**Subject:** FW: P2022/0433 (RECON) - NPT Hospital Baglan Way [STRl.rSny]

I note that the response refers to drawing number C7040-RVW-ZZ-00-DR-C-301 Rev P04. This was superseded by rev P05 submitted on the 10<sup>th</sup> June in response to previous comments.

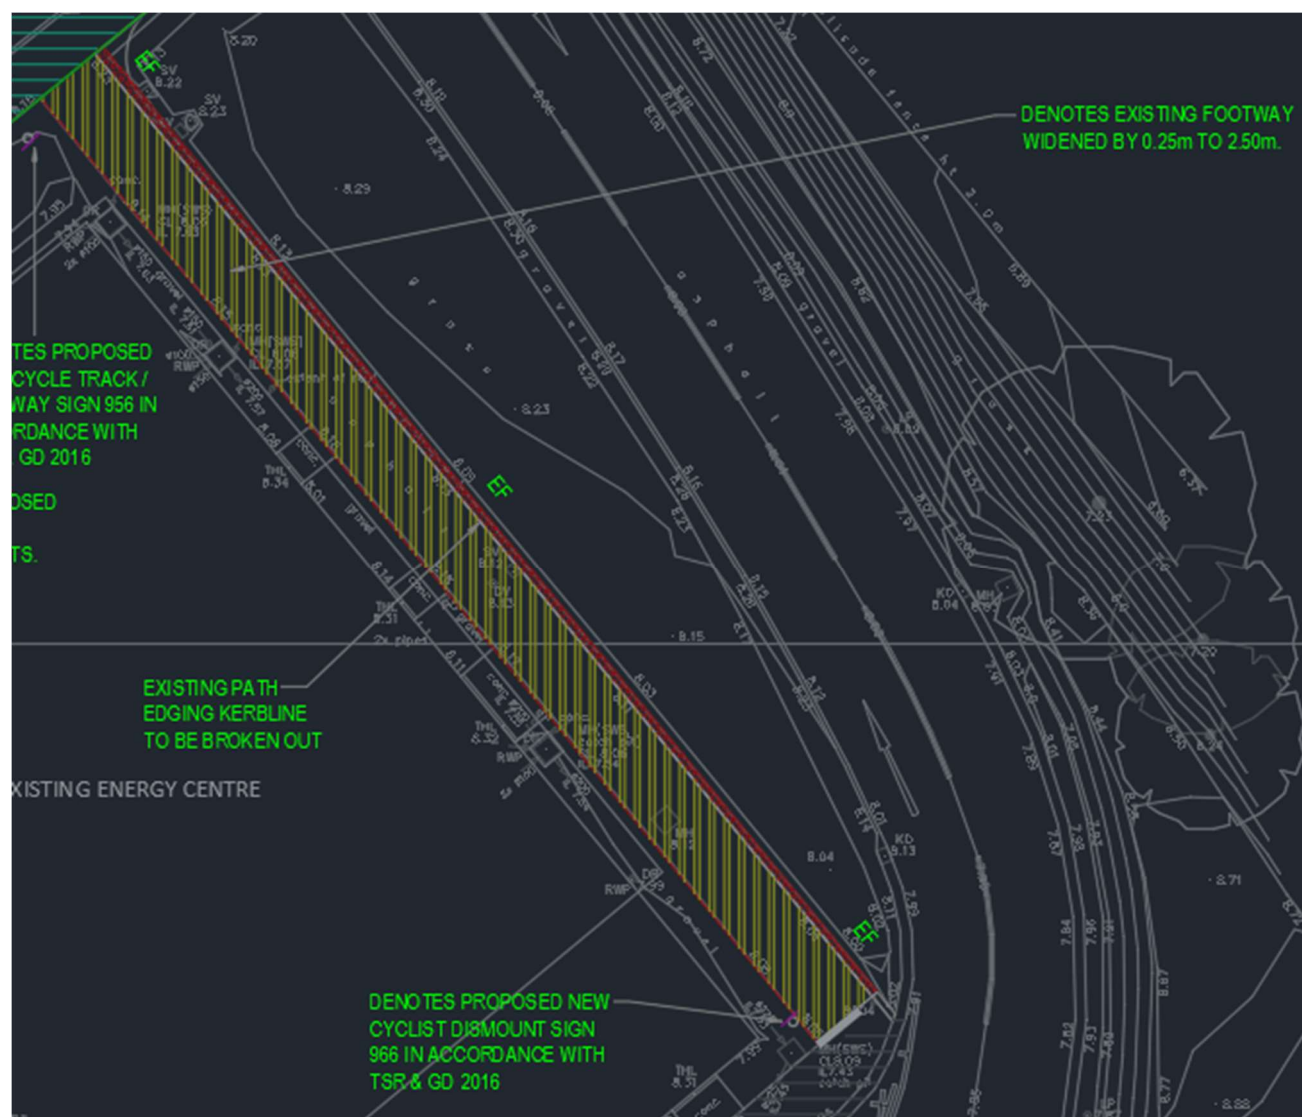
Nevertheless, in terms of the comments raised in point 1.

The relocated cycle way to the front and side of the proposed building extends to 3.02m and 2.71m as indicated below.

We are unable to increase the 2.71m stretch of the path adjacent to the existing access road due to the presence of the 2No. SuDs planters at the gable end of the proposed building which are required as part of the statutory SuDs requirements.

Where the path runs adjacent to the existing energy centre building, the increase to the width of the existing path has been kept at to 2.5m in order to avoid building over the existing water mains and water stop valves which run in the soft landscaped area adjacent to it (see screenshots below).
